Memorandum

From: 
Kit Custis, Sr. Engineering Geologist
PG#3942, CEG#1219, CHG#254
Department of Fish and Game
Fisheries Engineering Program
Regional Operations Division
1812 9th Street
Sacramento, CA 95814

Subject: Comments on October 2009 Draft EIR for the El Sur Ranch Water Right Application No. 30166.

Figure 9: Cliffs at El Sur Ranch Pasture 7 – October 2005
Close up of groundwater sapping erosion causing scalloped erosion head scarps

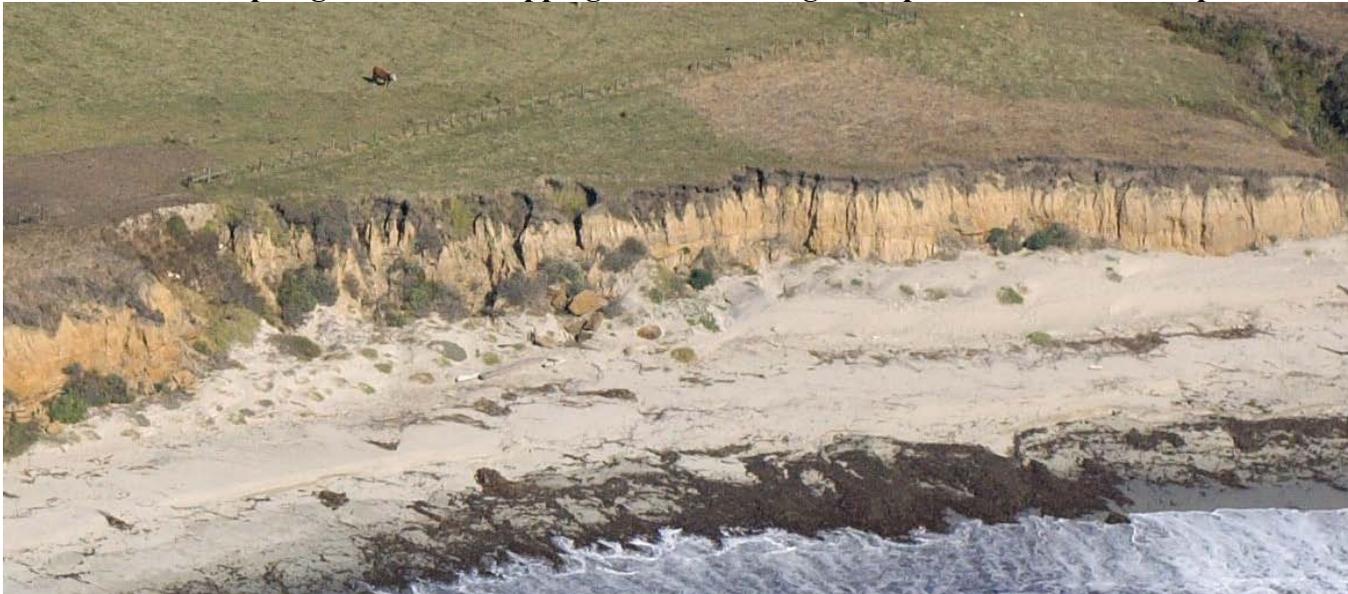
- a) Figures 4 through 10 show the section of the bluffs adjacent to pasture 7 and Swiss Canyon. This area lies approximately between the bluff survey points #1 and #2 in Hanson’s 2006 (2007c) monitoring study. Unfortunately, the older images are not as clear as the more recent ones, but I think that the two larger arcuate gully head scarps can be seen in the 1979 and 1989 image as well as a bluff that appears to have a shallower slope than in the later images. In the 2005 and 2008 images, Figure 7 through 10, the bluff shows a distinctive set of scalloped or “theater-headed” scarps at the head of a number of gullies. The number and density of these scalloped shaped gullies appears to have increased significantly between 1989 and 2005. The bluff erosion continued between 2005 and 2008, but because of the shorter period of time the change is less apparent.

The causes of these scallop shapes is discussed in some detail in USGS Professional Paper 1693 by Hampton and others (2004). They discuss the role of ground-water seepage on ocean cliff stability and note that when downward percolation of ground water is retarded by an impermeable horizon causing seepage along the cliff face it creates erosion. This ground-water seepage erosion is also called “sapping” which they note can resemble wave erosion, but the cause and remediations are different (page 20). The scalloped or “theater-headed” shapes at the head of the gullies are created by the concentration of ground-water flow. Hampton and others describe the erosion process as:

The addition of more irrigation water to the adjacent pastures from the baseline of approximately 3 feet to the application's 6 to 6.5 feet will likely add to the perched ground water on top of the clay subsoil. This perched water will eventually seep out at the cliff face and may increase the areas of saturation along with an increase in unstable areas. The DEIR should evaluate the source of the ground water seepage along the coastal bluff adjacent to the El Sur Ranch pastures and provide mitigation measures to ensure that irrigation practices do not cause or accelerate coastal bluff instability or erosion.
